## ALERT SERVICE BULLETIN

**505-23-35**

**MODEL AFFECTED:** 505

**SUBJECT:** OIL COOLER FAN ASSEMBLY HOUSING BRACKET, INSPECTION AND MODIFICATION OF.

**Figure 1 – Oil Cooler Blower Housing Installation (sheet 1 of 4)**

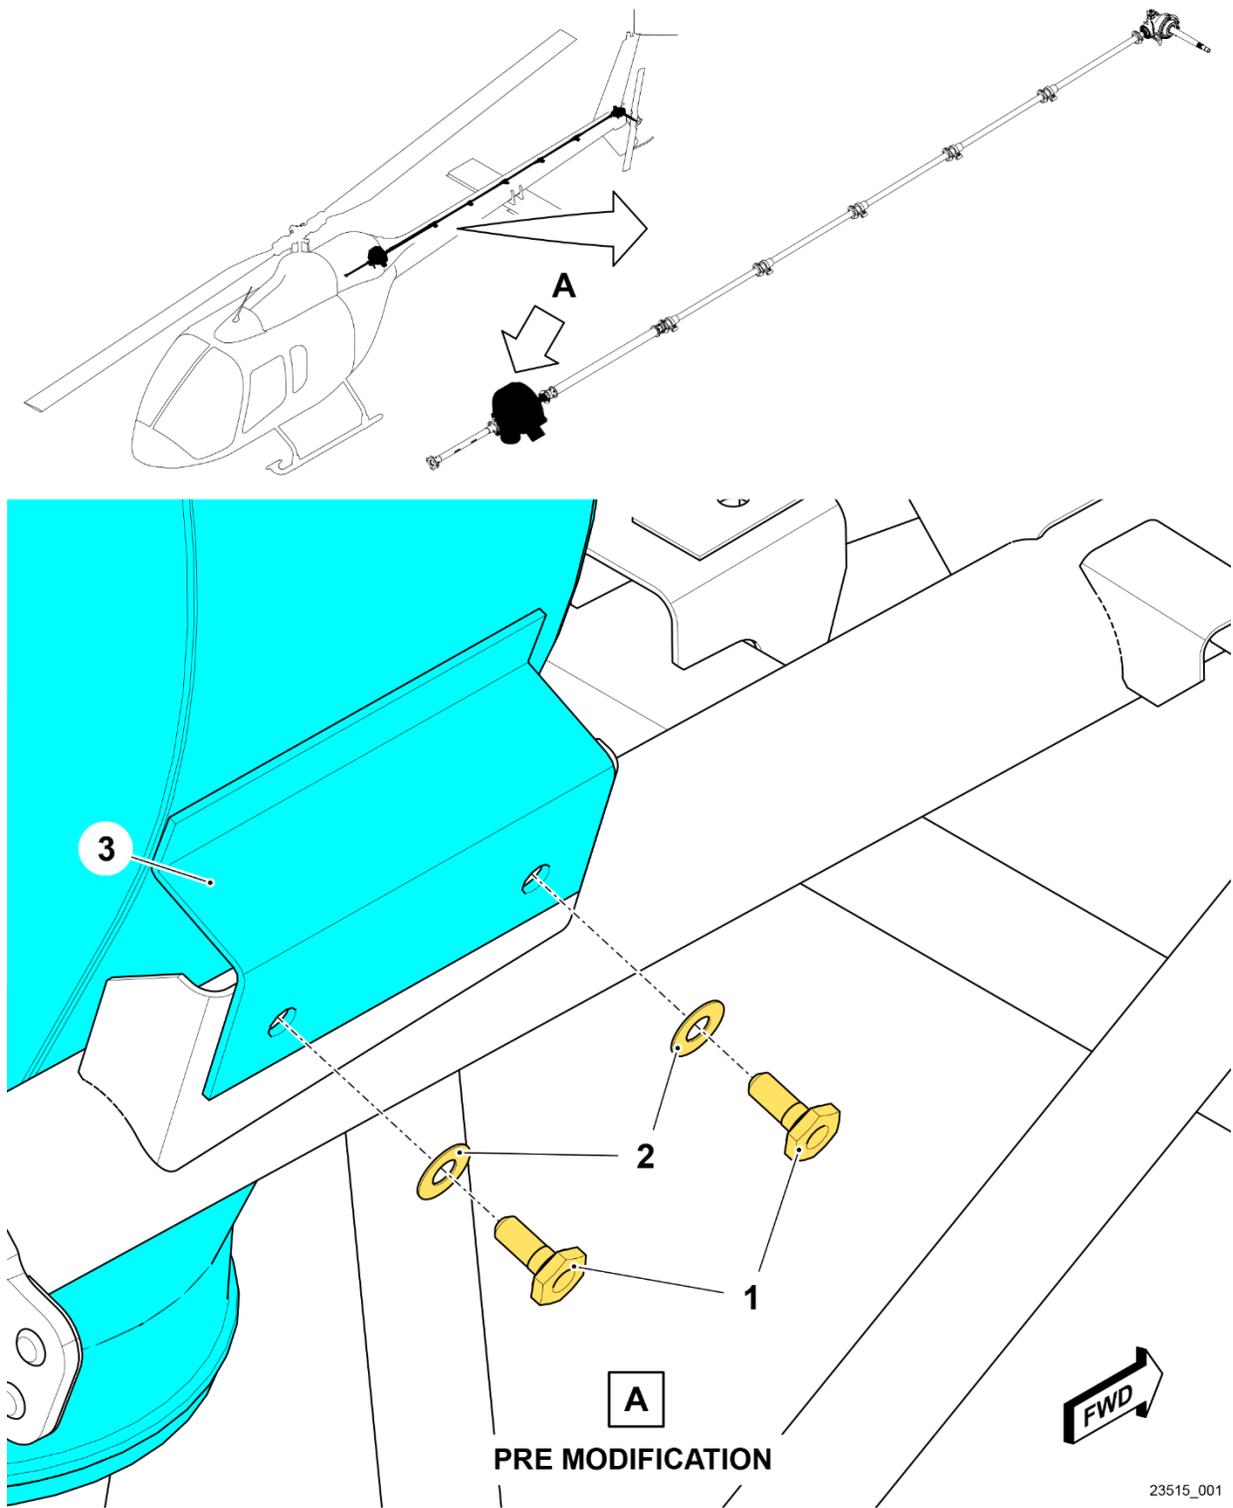
1. Prepare the helicopter for maintenance.
2. Remove the exhaust fairing (444AT) ([DMC-505-A-53-40-05-00A-520A-A](#)).
3. Using a 10X magnifying glass and bright light, inspect the right bracket (3, Figure 1, sheet 1 of 4) of the oil cooler blower housing for cracks.
  - a. If a crack is found, perform **PART II** of this bulletin prior to next flight.
  - b. If no cracks are found, perform **PART II** of this bulletin within 50 flight hours or 90 days, whichever occurs first, following the accomplishment of **PART I**. Go to step 4.

4. Remove bolts (1, Figure 1, sheet 1 of 4) and washers (2). Measure gap between bracket (3, Figure 1, sheet 1 of 4) and truss bracket (10, Figure 1, sheet 3 of 4).
  - a. If gap is less than 0.016 inch (0.406 mm), go to step 5.
  - b. If gap is 0.016 to 0.050 inch (0.406 to 1.27 mm), shim the gap using NAS1149D0316J and/or NAS1149D0332J washers. Apply sealant (C-308) on faying surfaces of washers prior to installation. Go to step 5.
  - c. If gap is greater than 0.050 inch (1.27 mm), perform **PART II** of this bulletin prior to next flight.
5. Apply corrosion preventive compound (C-104) to the shank of the bolts (1).

6. Install bolts (1), washers (2), and shims (washers) determined in step 4.b, if required. Torque bolts (1) 20 to 25 inch-pounds (2.3 to 2.8 Nm) plus the measured tare torque of 2 to 18 inch-pounds (0.2 to 2.0 Nm).
7. Install the exhaust fairing (444AT) ([DMC-505-A-53-40-05-00A-720A-A](#)).
8. Make an entry in the helicopter logbook and historical service records indicating compliance with **PART I** of this Alert Service Bulletin.

**Figure 1 – Oil Cooler Blower Housing Bracket (sheet 2 of 4)**

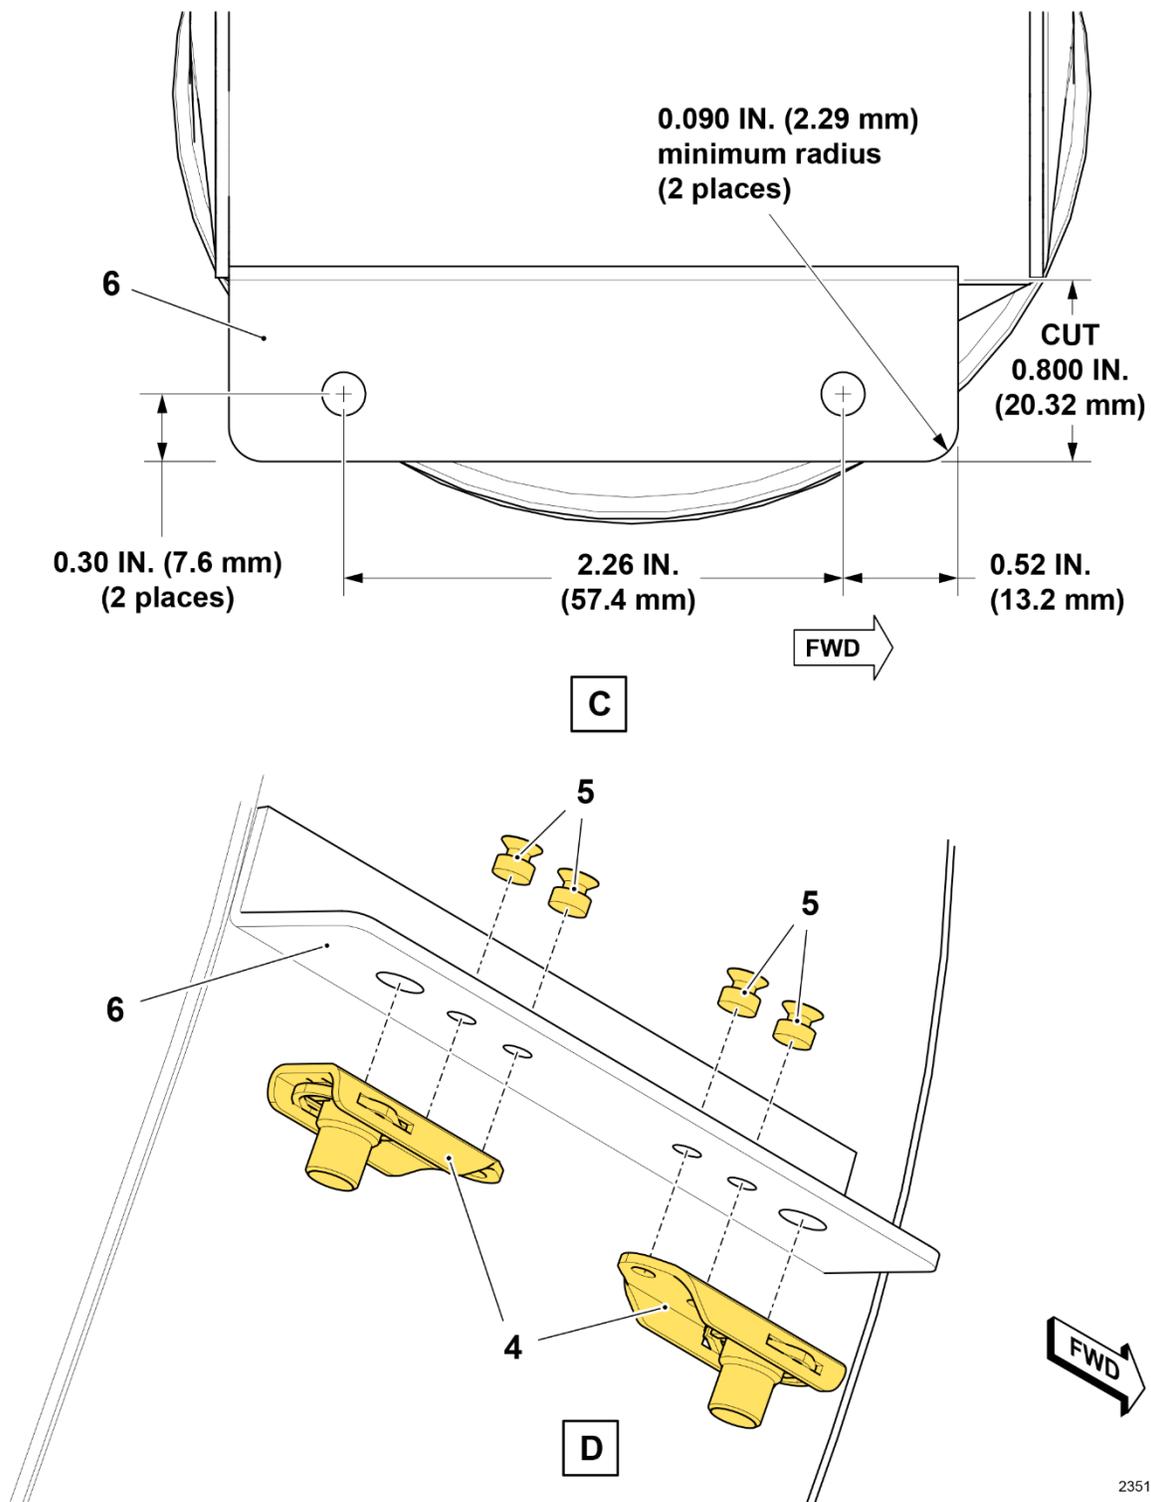
4. Cut right mounting bracket (6) (Figure 1, View C, sheet 2 of 4).
  - a. Cut to a dimension of 0.800 inch (20.32 mm) on the blower housing bracket (6).

- b. After being cut, discard cut (vertical) portion of the bracket.
  - c. Round outside corners of cut bracket (6) to a minimum radius of 0.090 inch (2.286 mm). Break all sharp edges.

5. Drill two holes using a 13/64 inch drill bit (5.159 mm) through the right horizontal bracket (6) of the blower housing (Figure 1, sheet 2 of 4). Debur holes.

6. While centering nutplates (4, Figure 1, sheet 2 of 4) over holes drilled in step 5, locate the attachment holes for both nutplates. The attachment holes of the nutplates (4) should be placed in a fore and aft direction as shown.

7. Drill the four holes located in step 6 using a 3/32 inch (2.381 mm) drill bit. Debur holes. Counter sink the holes from the top surface of the bracket (6) with a 100 degree countersink (Figure 1, sheet 2 of 4).

**Figure 1 – Oil Cooler Blower Housing Bracket (sheet 3 of 4)**

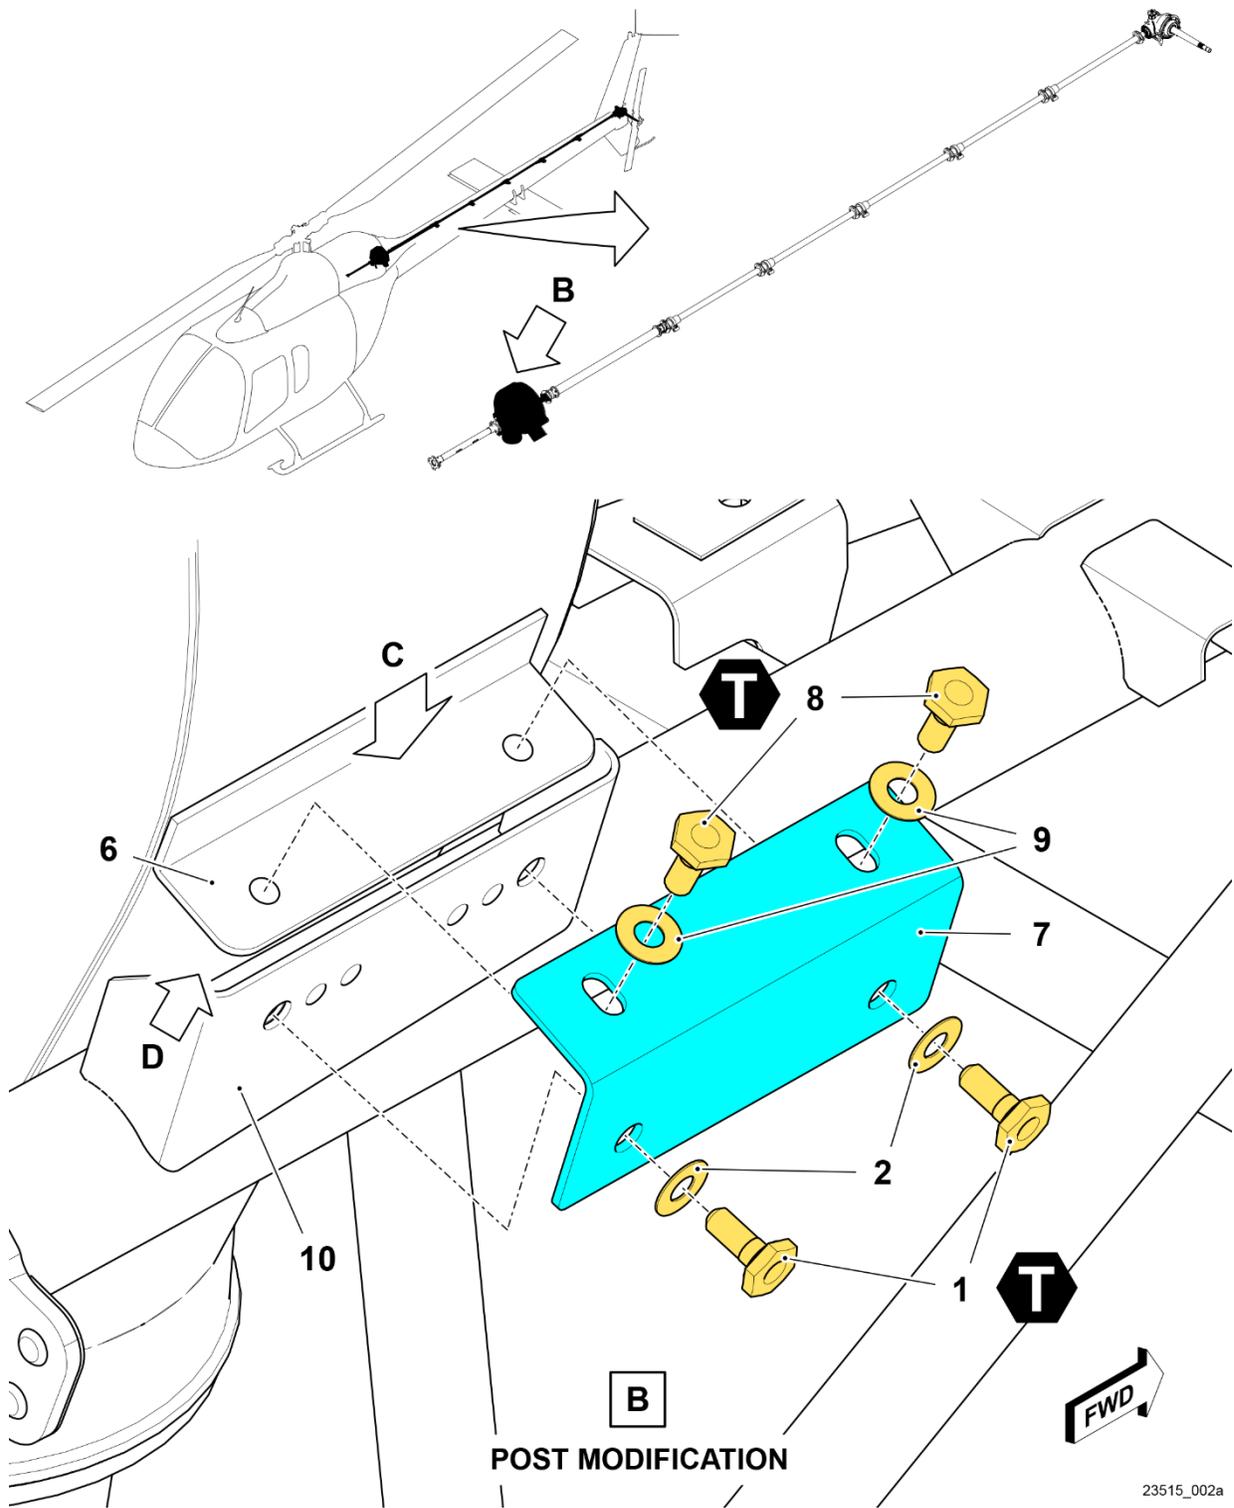
11. Install bracket (7) using bolts (1 and 8) and washers (2 and 9) (Figure 1, sheet 3 of 4) to blower housing bracket (6) and truss (10).

12. Torque the bolts (1 and 8) 20 to 25 inch-pounds (2.3 to 2.8 Nm) plus the measured tare torque of 2 to 18 inch-pounds (0.2 to 2.0 Nm).
  - a. Make sure no gaps exist between the bracket (7), oil cooler housing bracket (6), and truss (10).

- b. Make sure no fouling exists between bracket (7) and truss (10) weld bead.
  - c. Make sure that there is a minimum clearance of 0.050 inch (1.27 mm) between the forward face of the impeller and the housing of the fan shaft assembly.
